Agenda Item: 2017-01

2017 annual Technical Conference

Figure 46-4
Connection to Unit Equipment

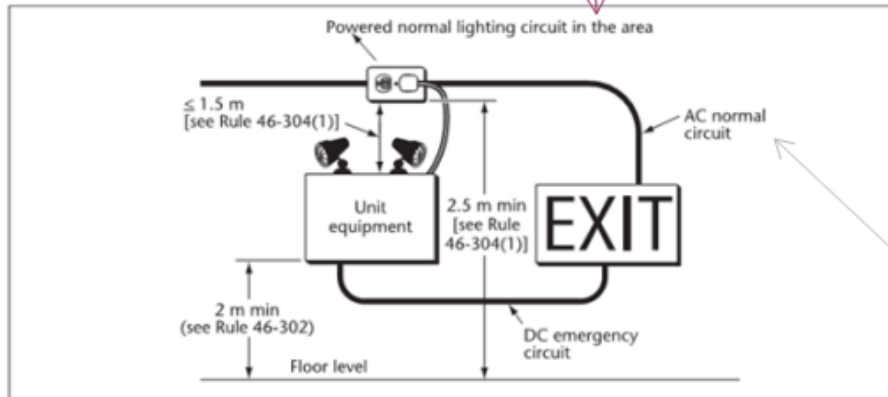
QUESTION 3: Is figure 46-4 in the handbook correct?

This indicates the unit equipment and the exit sign are supplied by the same circuit with the normal lighting in the area.

46-400 (1) says exit signs are to be on a dedicated circuit.

However, the requirement for a dedicated exit sign circuit is waived by (2) when the exit sign is connected to a circuit supplying emergency lighting in the same area where the exit signs are installed. (this includes unit equipment)

Question 3 - Is figure 46-4 in the handbook correct? **YES**

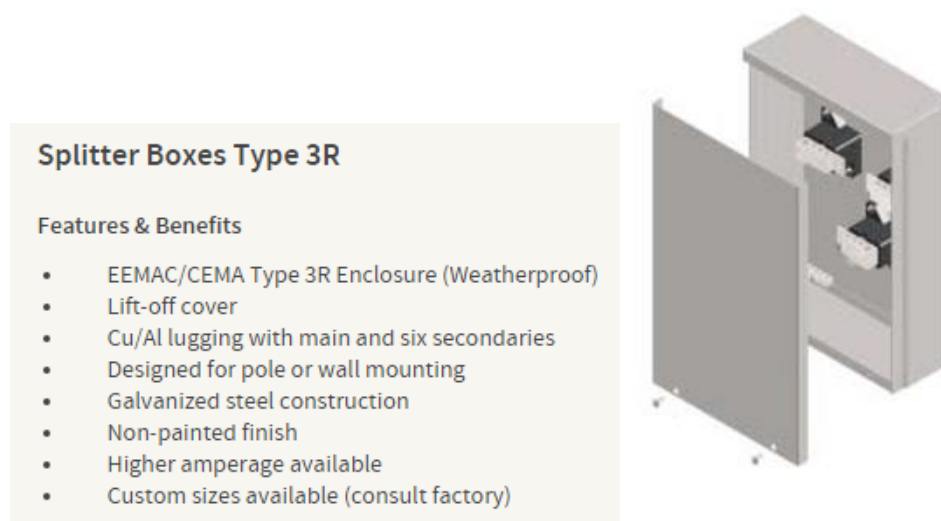
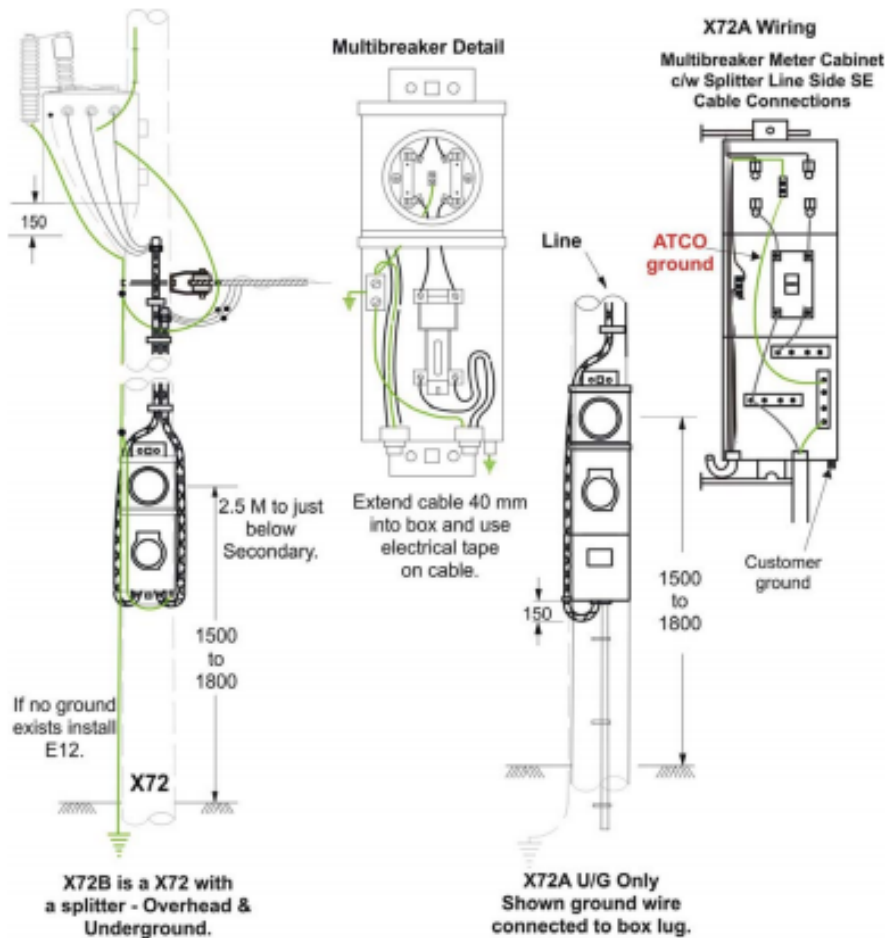
200 ampere 120/240 Volt service is supplied from a utility disconnect mounted on a farm service pole. The service requires 2 sets of 4/0 AL USEB cables for voltage drop. A transition is required to accommodate terminations in the 200 ampere main breaker in the building.

The contractor intends to install a splitter at the building, or use a wireway to solidly splice, conductors terminating in the service main breaker. The conductors are to be sized to meet 4-006 temperature limitations. The installation meets the requirements of Rule 14-100(g) CE Code.

Question: Is this installation acceptable without a separate disconnect at or near the pole?

An in-depth discussion was held on the question. Although it was initially recommended that the installation be considered acceptable, it was suggested this question be forwarded to the Electrical Sub Council for further discussion.
